Amendment Report for the Application of a Substantive Amendment to the Environmental Authorisation issued for the development of the 140 MW Sutherland Wind Energy Facility, Sutherland, Northern and Western Cape Provinces

# DRAFT AMENDMENT REPORT

*DEA Ref Number:*  
12/12/20/1782/2/AM3

October 2019

Figure 4: Changes in specifications of turbine dimension

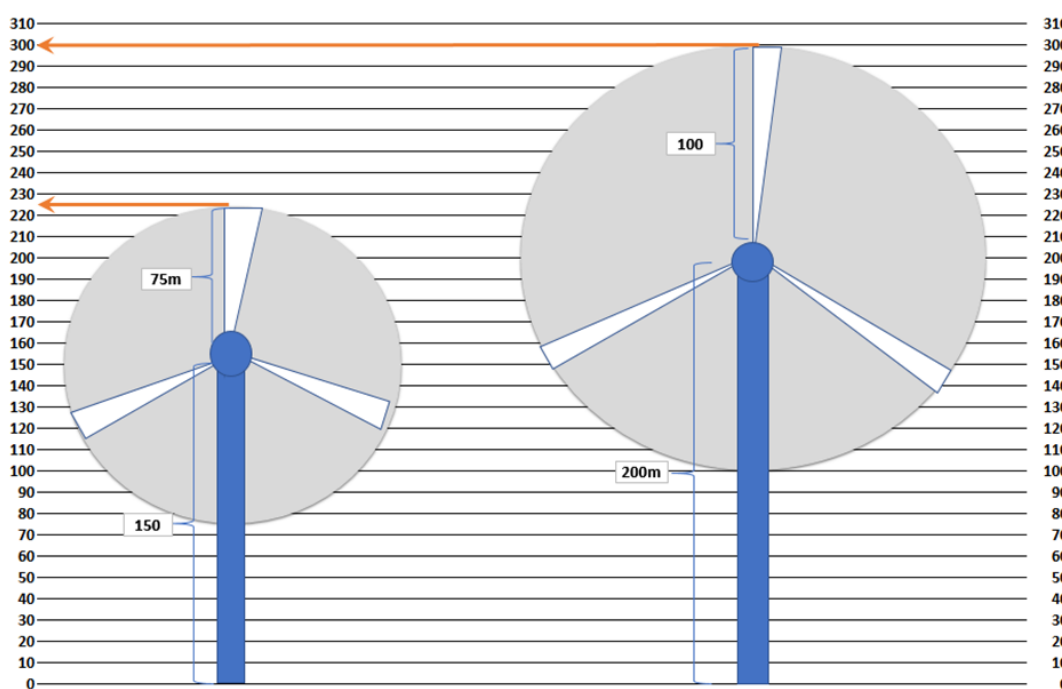
The main negative impact of turbines on bats is the encroachment of air space where bats forage or commute. Table 7 and Figure 4 indicate the increase in the volume of the total swept area, if turbine sweep is calculated as a sphere. For example, should 39 turbines be installed, with a hub height of 200 m and a rotor diameter of 200 m, there will be a 65.08 % increase in swept area. The lowest point of the sweep of the turbine blades is also indicated, as this could have an impact on bat mortality (see Literature review in Section 4.1 of the Bat specialist report (Moir & Dippenaar, 2019, included in Appendix C of this report).

Figure 6. Sutherland WEF Viewshed: Amendment 2019: 200 m Hub Height (Oberholzer and Lawson, 2019).

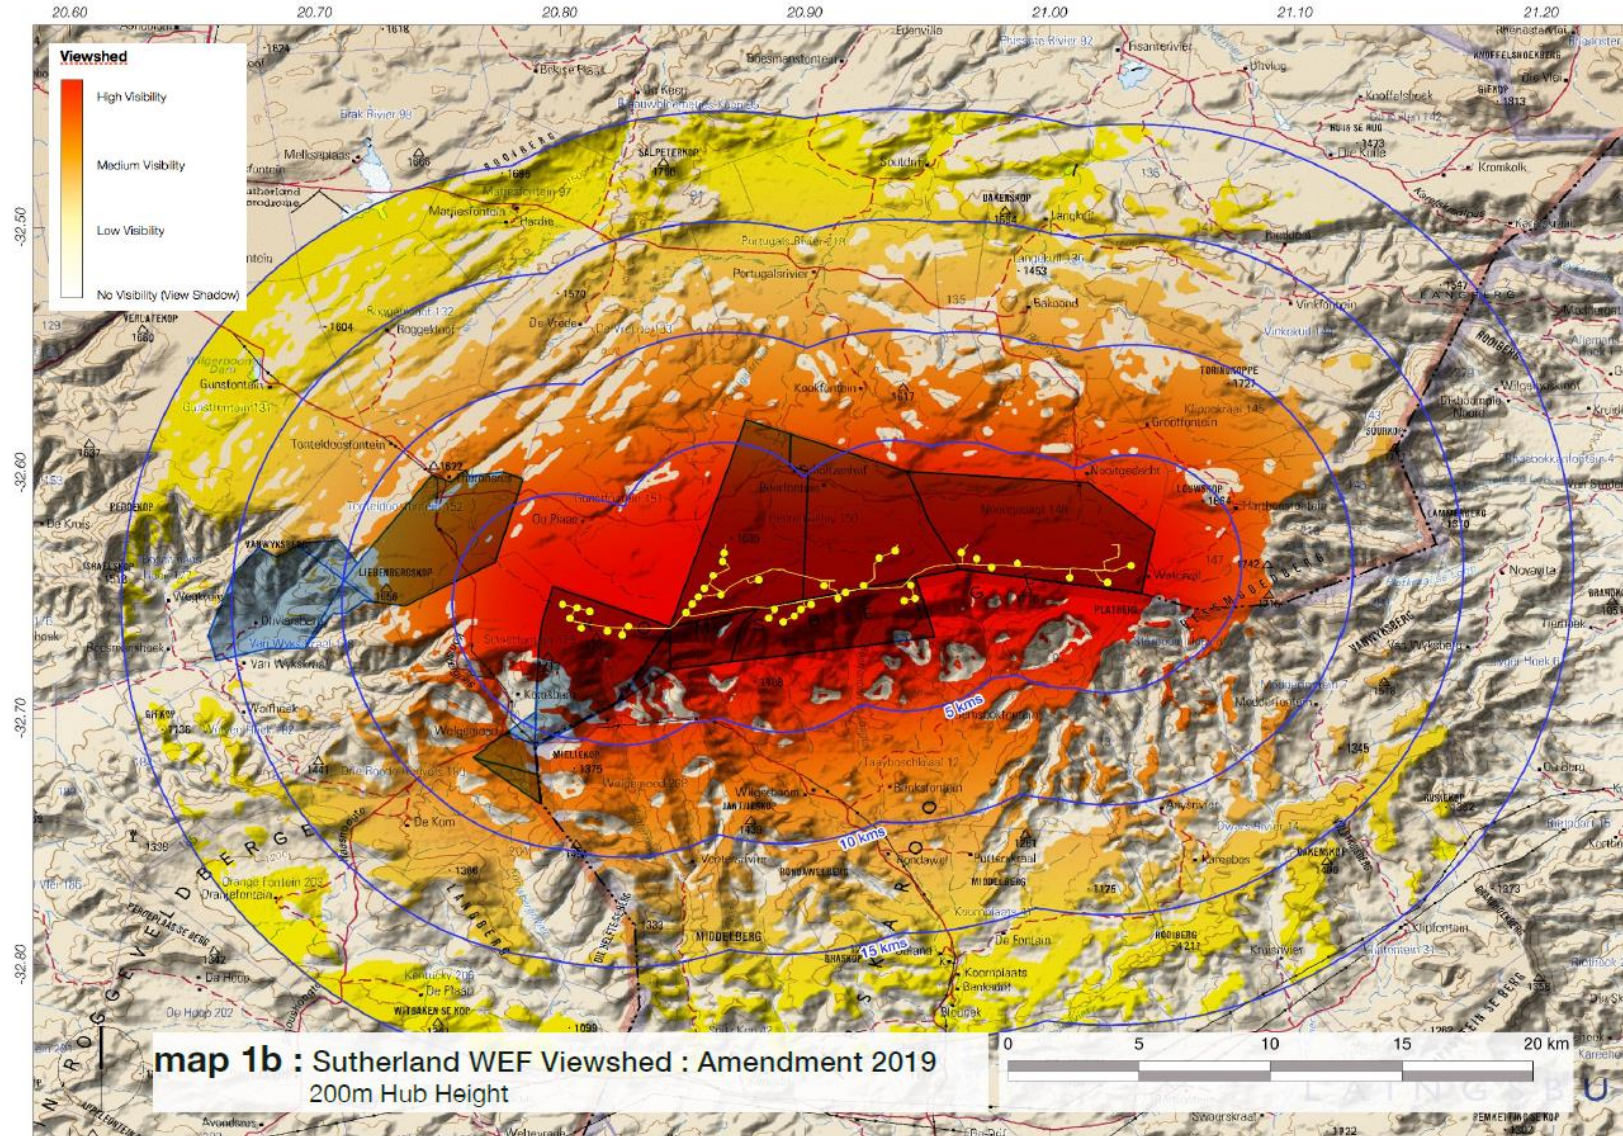
A revised viewshed for the larger turbines has been prepared to determine the visual exposure on the surrounding landscape and receptors, and whether there would be any increase in visual impact significance (see Figure 6). The current viewshed provides a useful comparison with the viewshed of the previous Amendment 2 layout, there being fairly minimal difference in visual exposure, the visual effect of which would decrease with distance.

Figure 10: Authorised layout and amended layout of the Sutherland Wind Energy Facility

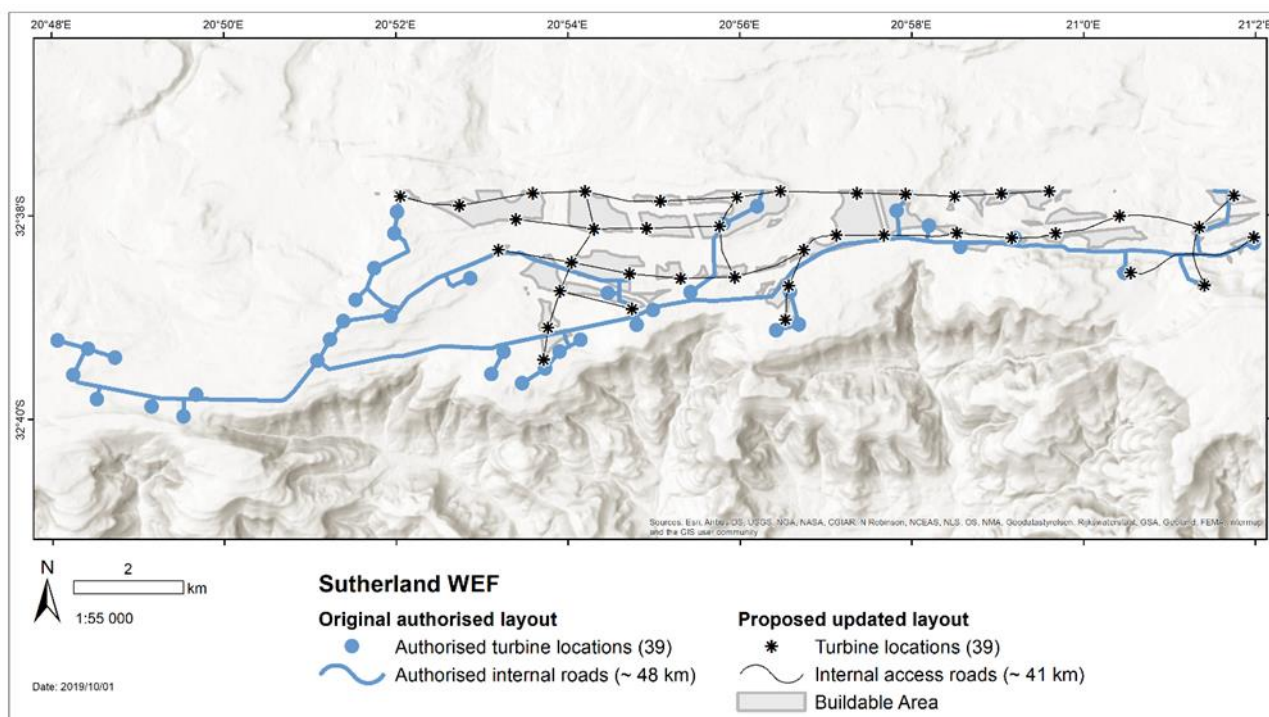
The Sutherland WEF layout has been amended to avoid sensitive environmental features - specifically avifauna and bat buffer areas and a visually sensitive escarpment that dominate most of the Schietfontein 1/179, Botmanshoek 1/10 and Botmanshoek RE/10 farms.

The specialists have assessed the potential impacts which the proposed changes in the turbine specifications (i.e. an increase in the hub height and rotor diameter from 150m to 200 m) may have on the affected environment. Based on their findings and recommendations the layout has been amended to avoid sensitive environmental features - specifically avifauna and bat buffer areas and a visually sensitive escarpment that dominate most of the Schietfontein 1/179, Botmanshoek 1/10 and Botmanshoek RE/10 farms. It is emphasised that the implementation of the proposed amendments to the Environmental Authorisation and to the proposed Sutherland WEF will not result in additional or unacceptable environmental impacts. This was confirmed by the specialists on the project team (section 4.3-4.8) and the specialist's inputs found in Appendix C of this report. As part of the planning mitigation strategy, the applicant considered all the above-mentioned findings and sensitivities, and duly made the necessary amendments to the layout considered in the EIA in order to reduce impacts to an acceptable level. It is emphasised that it still falls within the approved remaining buildable area Figure 10.

Figure 12. Environmental sensitivity map overlay with the turbine locations for the Sutherland WEF

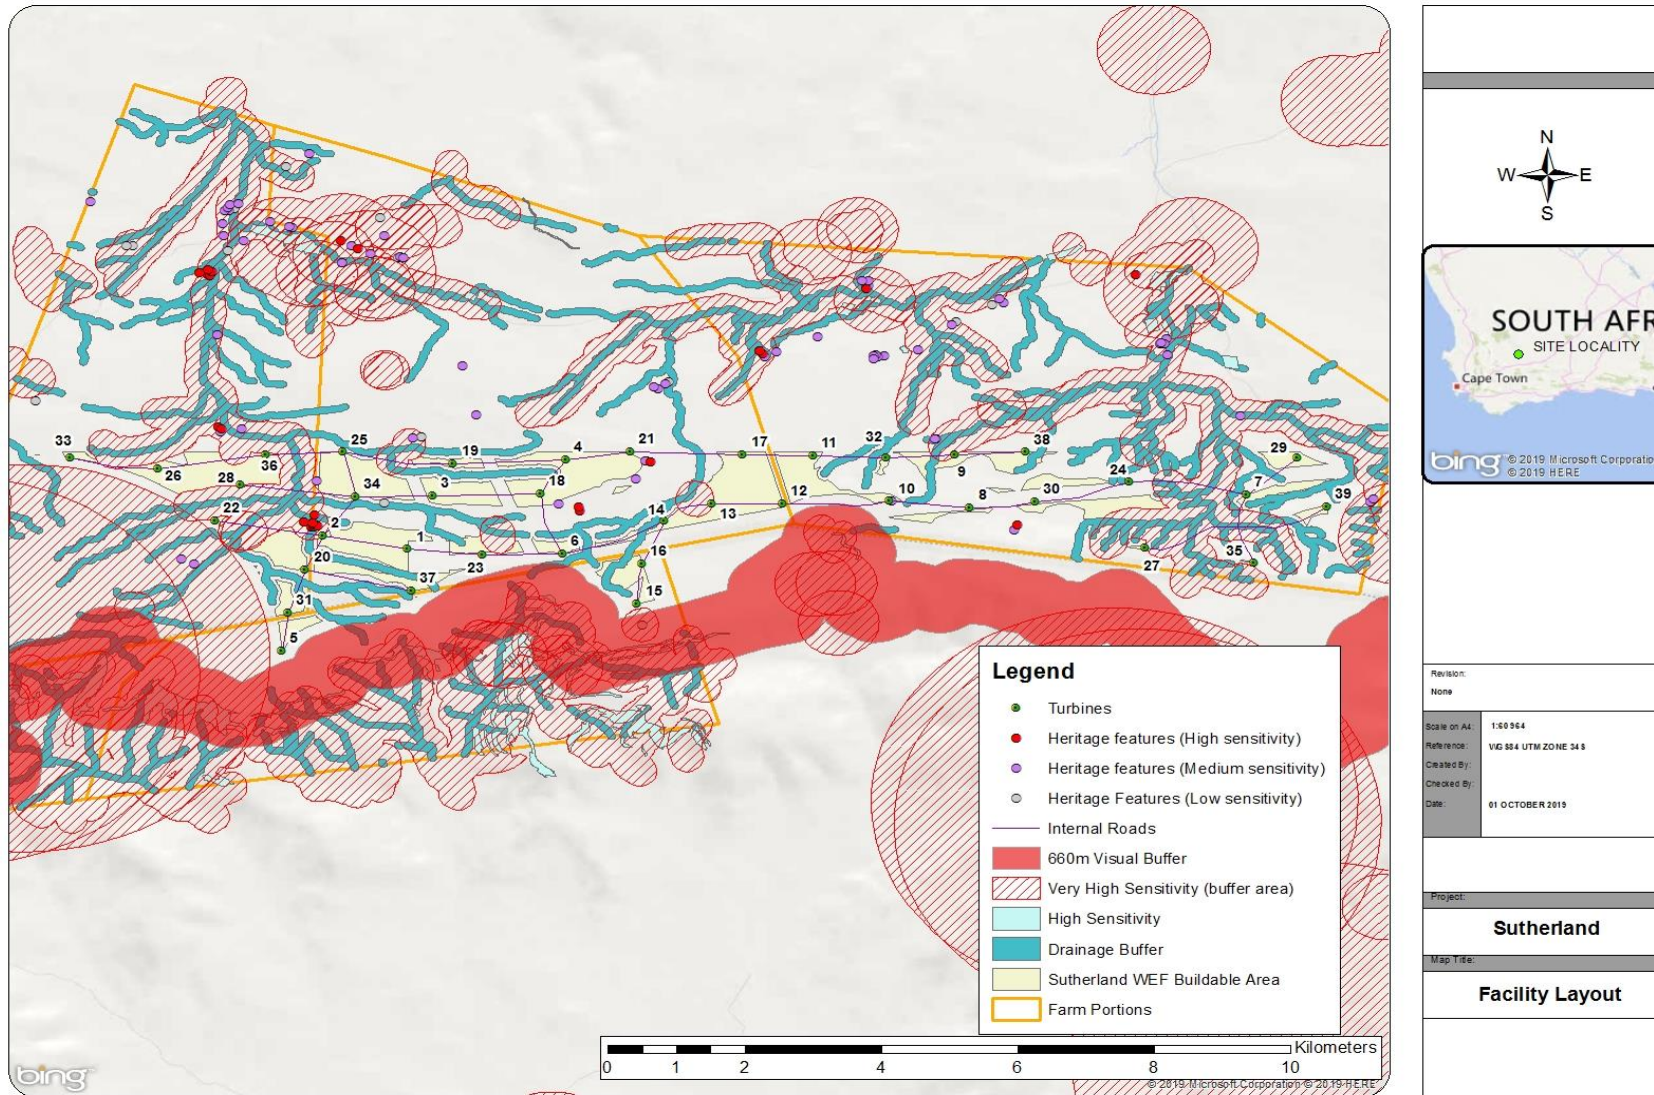
The proposed layout, which incorporates larger turbines has been amended to include the buffer areas as provided by the specialists, specifically avifauna and bat buffer areas and a visually sensitive escarpment that dominate most of the Schietfontein 1/179, Botmanshoek 1/10 and Botmanshoek RE/10 farms. This has resulted in a reduced buildable area.

In addition to this, the layout of the proposed Sutherland WEF has been amended to avoid all the environmental sensitive features and buffers as identified by the specialists. In light of the fact that the previously assessed buildable area now encroaches into the revised sensitive areas, Mainstream has clipped the buildable area to ensure that the sensitive areas are avoided.
